Amend approved Site Plan for Building Permit to split commercial lot line into two parcels and to amend the Site Plan for Building Permit to add in an additional ADA space on the car wash parcel.

RE: PROJECT ADDRESS – 5401 SEVILLA AVE NW, ALBUQUERQUE, NM 87120

**ADMINISTRATIVE AMENDMENT TO OVERALL SITE PLAN FOR SUBDIVISION
AND SITE PLAN FOR BUILDING PERMIT**

FILE #: SI-2022-00314

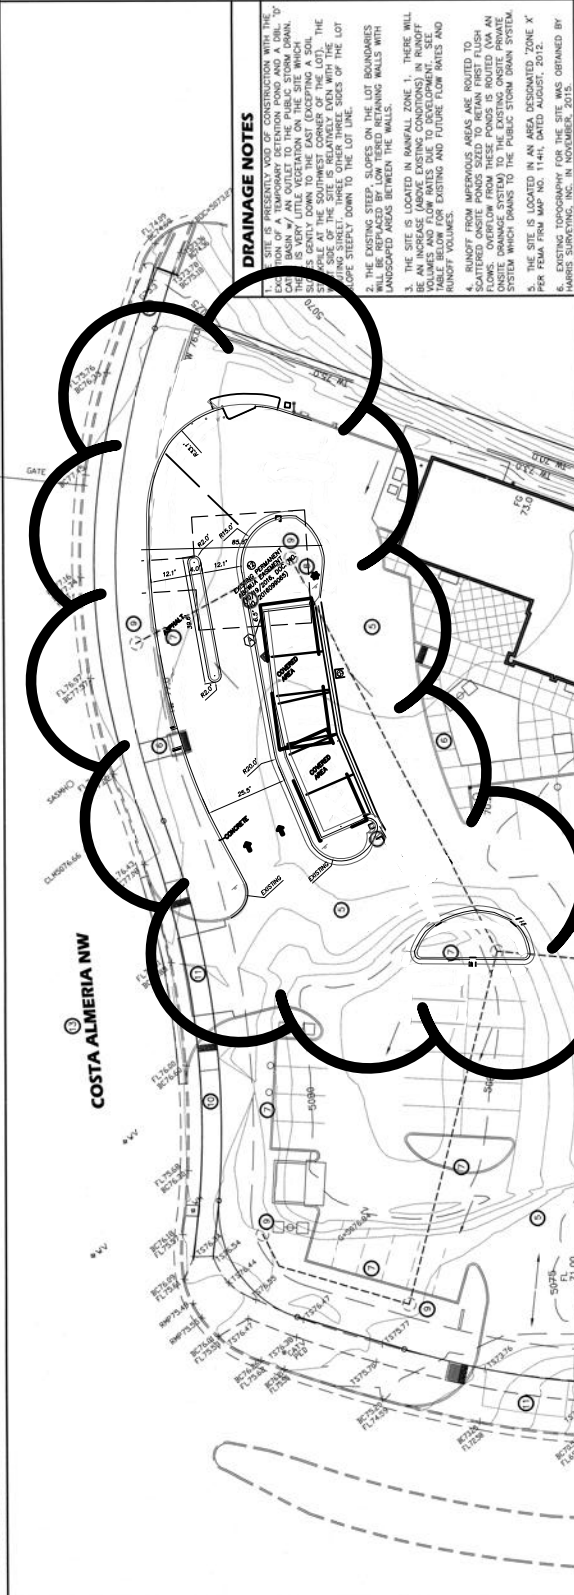
Relocation of existing automated pay station west of existing location. No additional
changes to grading and drainage, parking, site circulation, or site configuration.

1 SITE PLAN
 1" = 20'-0"

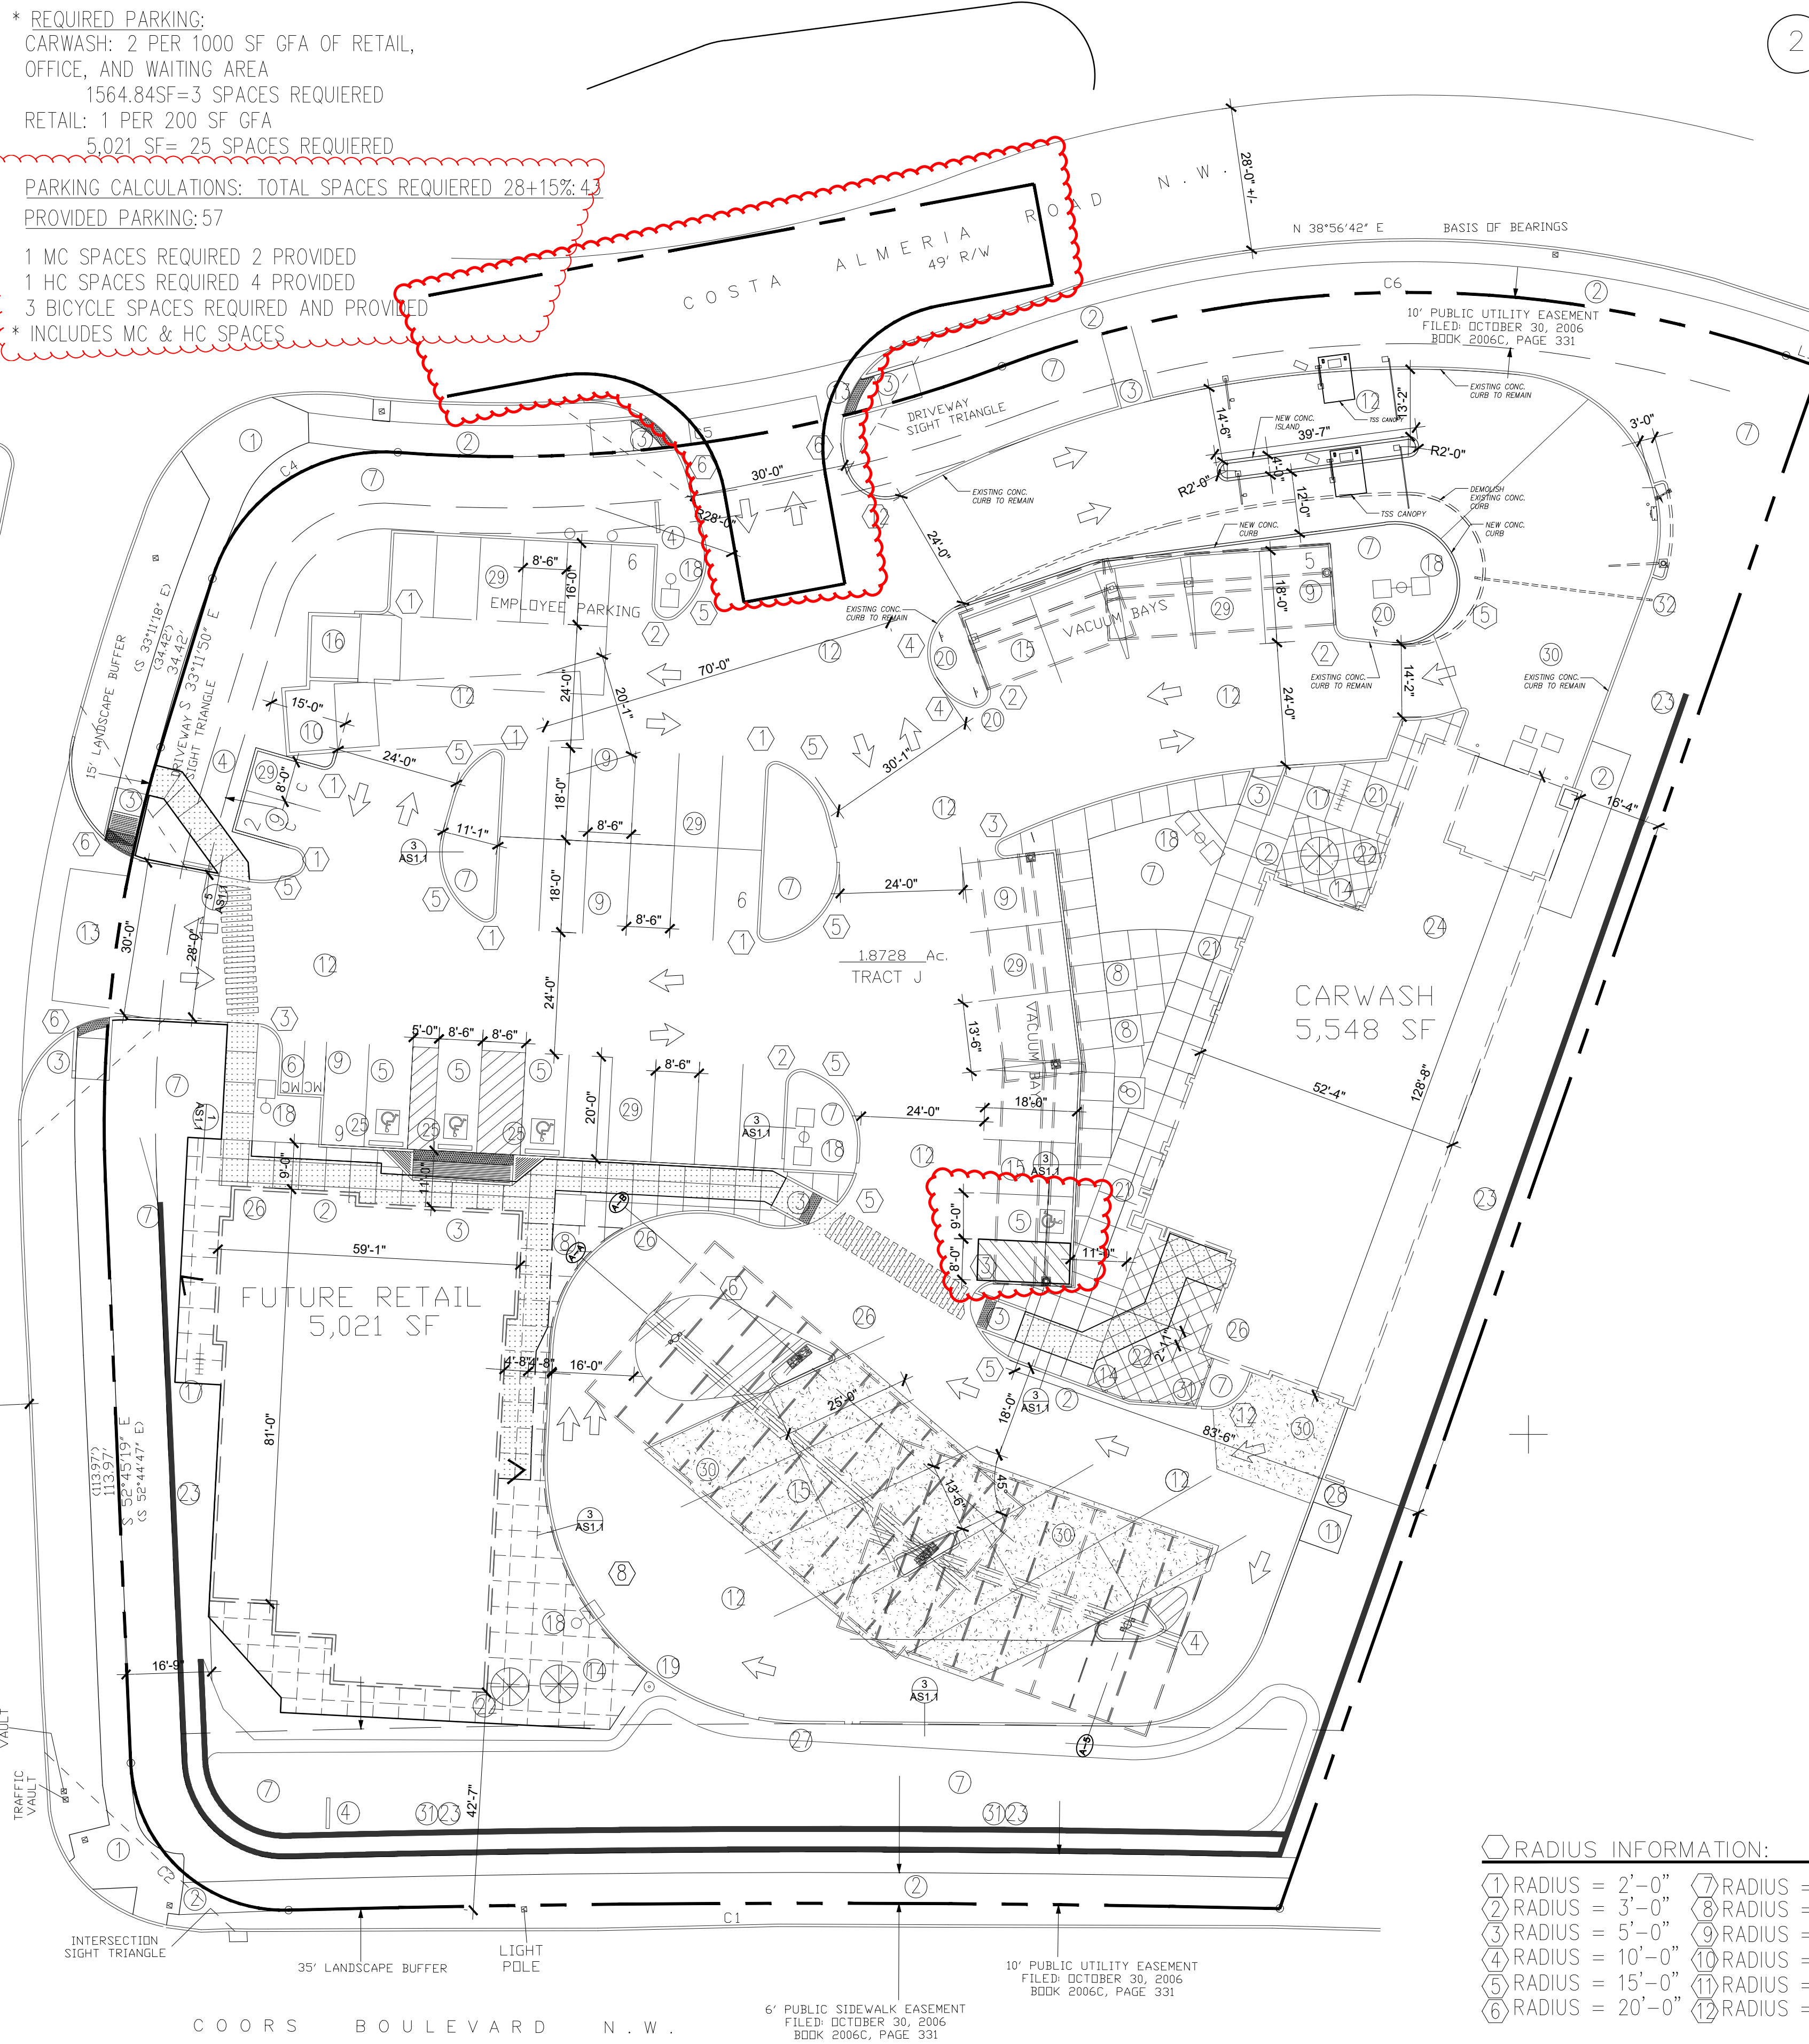
Site Plan for Building Permit:

- Parking calculations have been updated.
- The Site Plan shows the new location of the ADA parking space.

- The lot has been split from 1 existing lot into 2 lots and is reflected on the plan.
